NPP Gravelines Reactor 2 & 4
LTO Environmental Impact
Assessment

Expert Statement

Contracting authority Federal Ministry of Agriculture and Forestry, Climate and Environmental Protection, Regions and Water Management; Directorate General VI – Environment and Climate; Directorate VI/8 General Coordination of Nuclear Affairs

Figure 2: French active fault database and location of the Gravelines reactors
(redrawn from: JOMARD et al., 2017; RITZ et al. 2021).

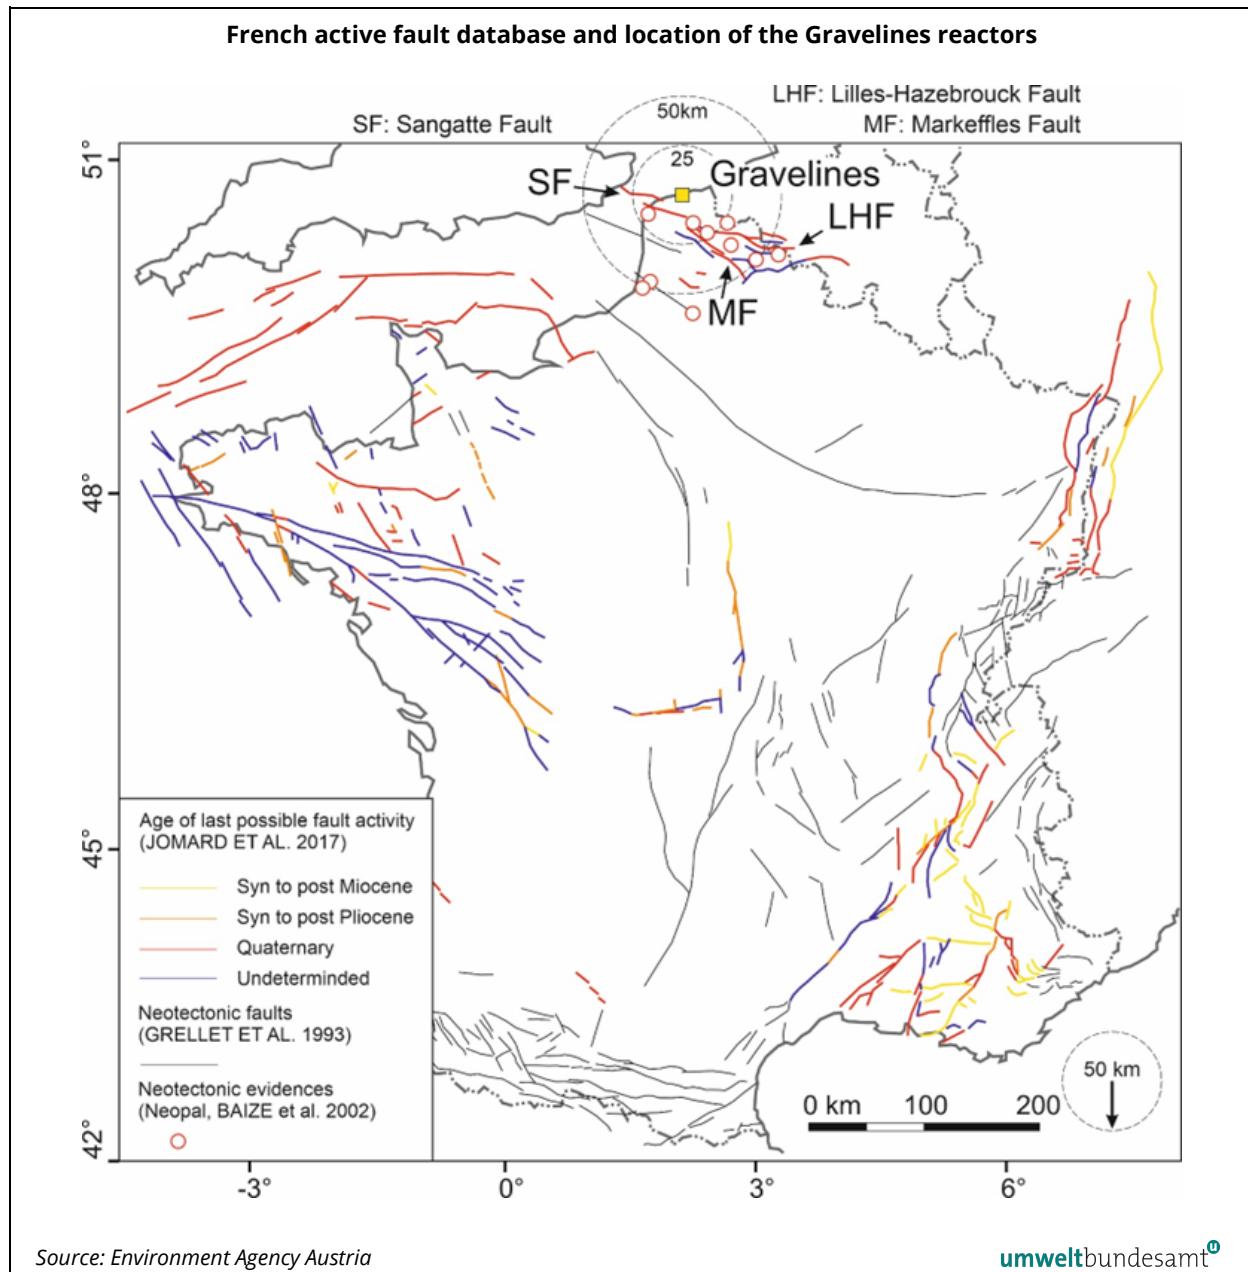
return period of 20.000 years. No PSHA results other the single value characterizing the SND are communicated. Documents, in particular, do not show hazard curves and do not state a ground motion value characterizing the 10,000 years earthquake (occurrence probability of 10^{-4} per year) which, according to WENRA (2021), shall be used to define the seismic design basis of existing NPPs¹⁶. It is therefore unclear if the deterministically derived seismic design basis value for the Gravelines units, the SMS with 0,2 g¹⁷, envelopes the ground motion value of a PSHA-derived design basis earthquake with an average recurrence interval of 10,000 years. The high value for the SND (0,41 g) suggests that this may be not the case.

The EIA documents do not provide information on the methods, data and assumptions of the PSHA other than claiming that "*seismic studies [are] compliant with international best practices (Type 1 study)*". The notion of type 1 study remains unexplained. With respect to methods and data it is worth noting that state-of-the art PSHA is based on both, earthquake and active fault data. Both, EIA-REPORT G2 P.2 (2025) and EIA-REPORT G4 P.2 (2025) provide evidence that EDF is aware that geological and seismological data indicate the existence of several active faults in the near-region and region around the Gravelines site, but it seems that these faults are not taken into account as fault sources in the PSHA performed to establish the SND and/or the seismic PSA. The active fault map by JOMARD et al. (2017) shows several Quaternary faults within a distance of 25 km from the site (near-region of the site to IAEA 2022), and numerous locations in the same area for which data exists in the Neopal neotectonic database (BAIZE et al. 2002; NEOPAL 2009). Evidence for Quaternary faulting particularly exists for offshore faults in the Dover Strait (Sangatte fault), the Marqueffles fault and the Lille-Hazebrouck fault (RITZ et al. 2021; GARCIA-MORENO et al. 2015). All of the named faults belong to the fault systems between the London-Brabant Massif and the Paris Basin which are known to EDF and referred to in the EIA documents (Nord-Artois-shear zone and the Brabant fault). For such proved or potentially active faults WENRA (2020b p.11ff) suggests systematic fault mapping and collecting paleoseismologic information. Efforts should at least be made in the near-region of the site (not less than 25 km) to collect geological, geophysical, geomorphologic, geodetic and paleoseismological data for identifying and characterizing active faults. Noteworthy, EDF considers that "*the acquisition of new data (high-resolution subsurface geophysics, and possibly paleoseismological trenching and dating) could be undertaken in the coming years*". At the background of the existing literature (RITZ et al. 2021 and references therein) it is remarkable that the procedure has not yet been definitively established.

Figure 4: Cooling devices in the event of core meltdown (EIA-REPORT G2 P.1 2025)

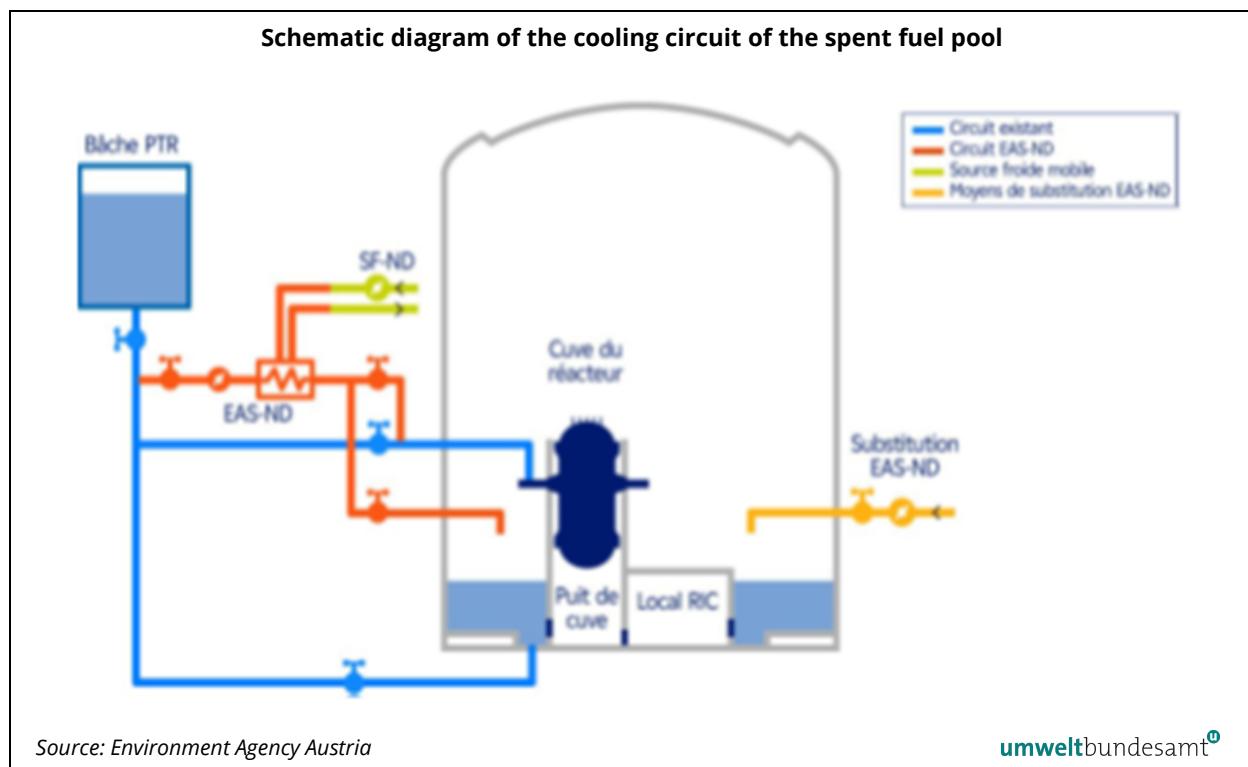
The coolability of the corium in the ex-vessel phase was subject to large uncertainties. The geometry of the 900 MWe reactor cavity bottom consists of a circular cylinder of inner radius 2.6 m, sided by a rectangular area facing the RIC room), whose dimensions are approximately 4.0 m x 2.6 m. Thus, the total area of reactor pit and RIC room is 31.6 m². Referring to the indicative figure of 0.02 m²/MWth this translates to a necessary area of approximately 55 m² for the 900 MWe reactor. Consequently, the coolability of the corium is unlikely (ASAMPSA 2013)
